Subject: City of St. Paul Park 2040 Comprehensive Plan and Comprehensive Sewer Plan, Review File 22308-1

REVIEW RECORD

City of St. Paul Park 2040 Comprehensive Plan

Review File No. 22308-1, Business Item No. 2020-150 JT

Figure 1. Location Map with Regional Systems

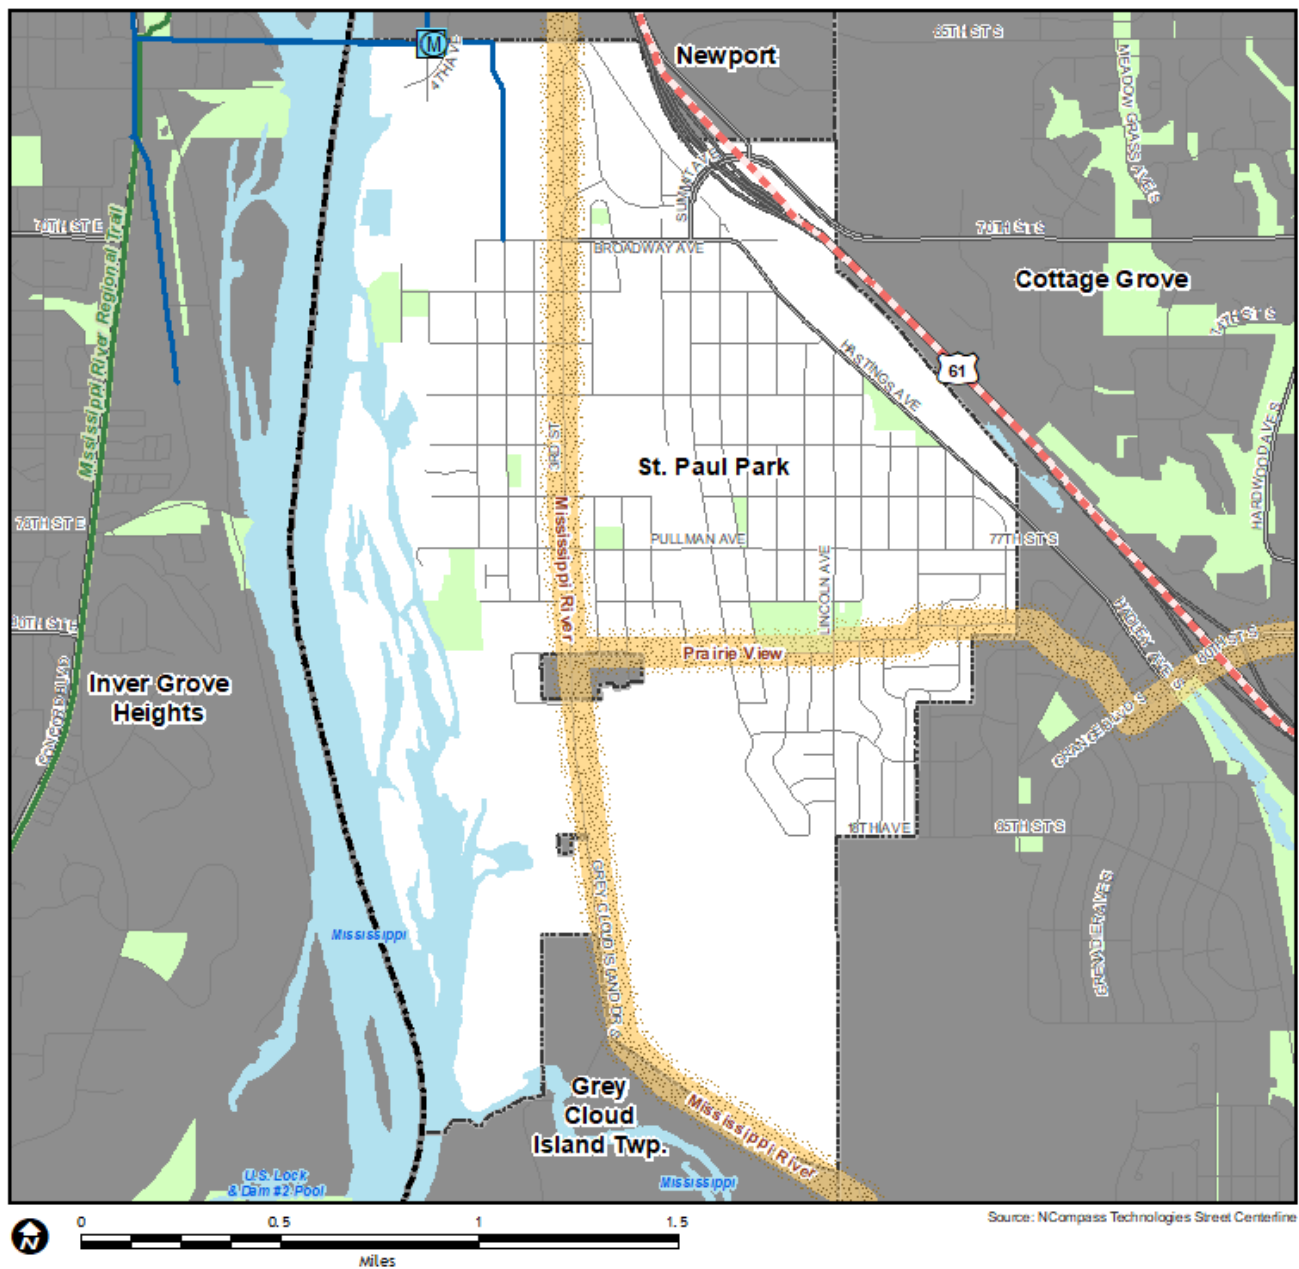
The Plan conforms to the 2040 Regional Parks Policy Plan (RPPP) for the Regional Parks System element. Washington County is the Park implementing agency for Regional Parks System components in St. Paul Park, for which the Plan accurately describes the Regional Parks System components. Regional Trails located within the City include the Mississippi River and Prairie View regional trail search corridors (Figure 1). There are no federal or state recreation lands within the City.

Figure 2. Thrive MSP 2040 Community Designations

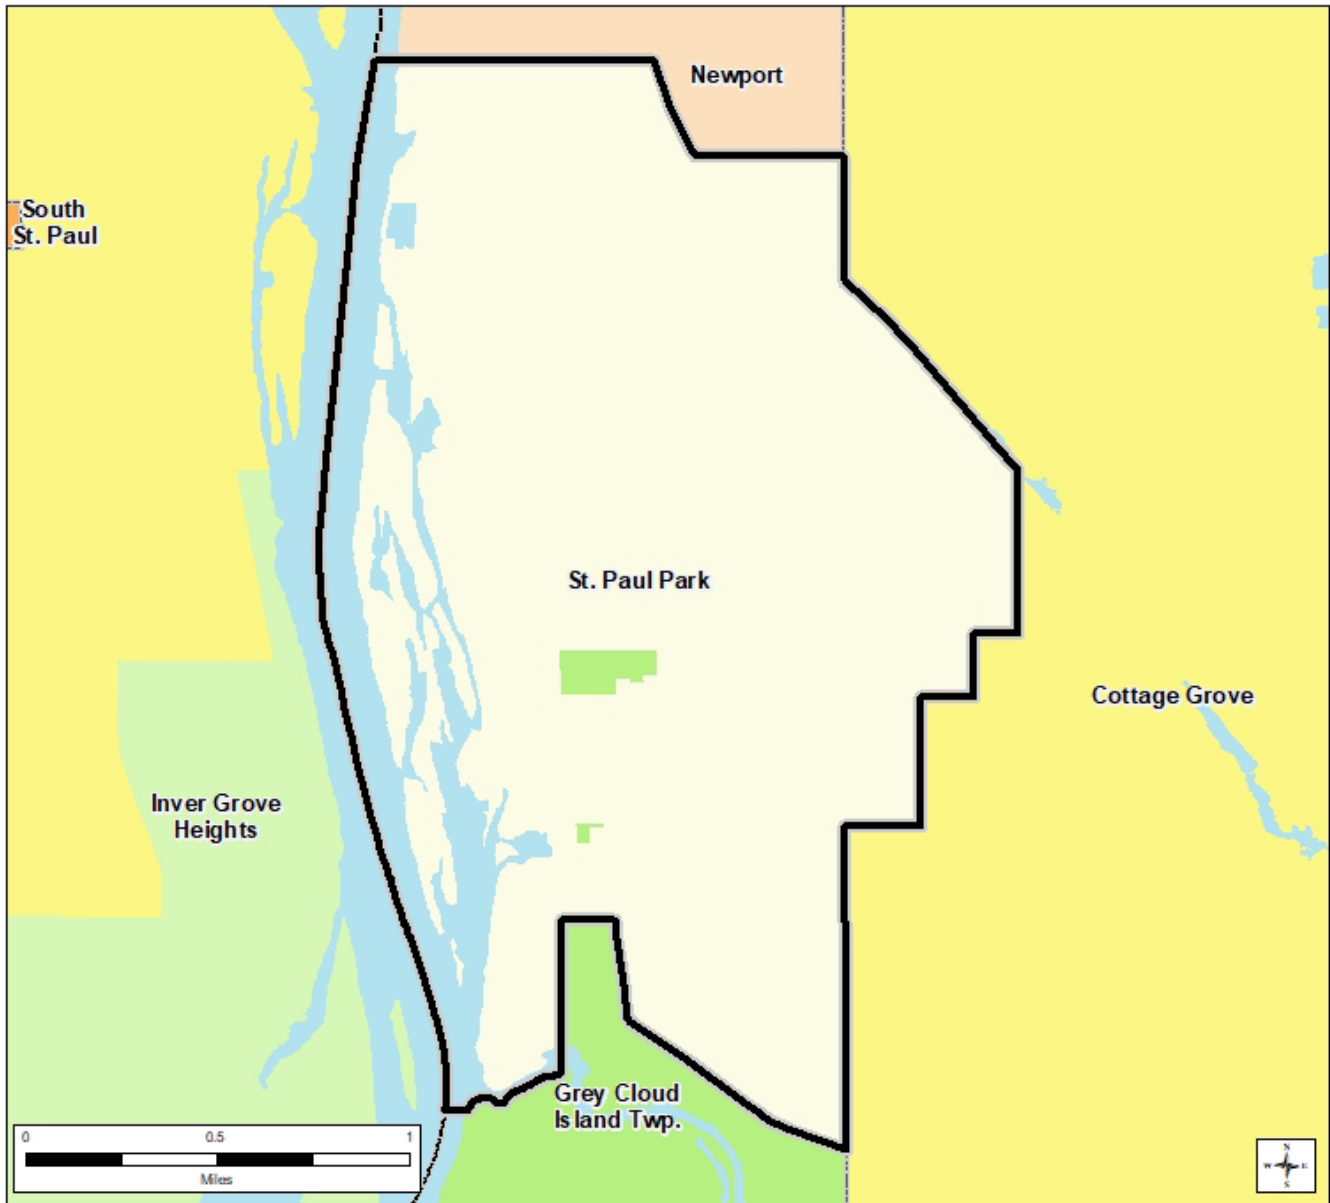
The Plan is consistent with *Thrive MSP 2040* (Thrive) and its land use policies. The Plan acknowledges the Thrive community designation of Emerging Suburban Edge (Figure 2). Thrive describes Emerging Suburban Edge communities as those that are in the early stages of transitioning into urbanized levels of development. Emerging Suburban Edge communities offer both connections to urban amenities and the proximity to open spaces that characterizes a rural lifestyle. Communities in the Emerging Suburban Edge have a mix of residential, rural, and agricultural areas, often including lower-density single-family neighborhoods and small downtown service centers.
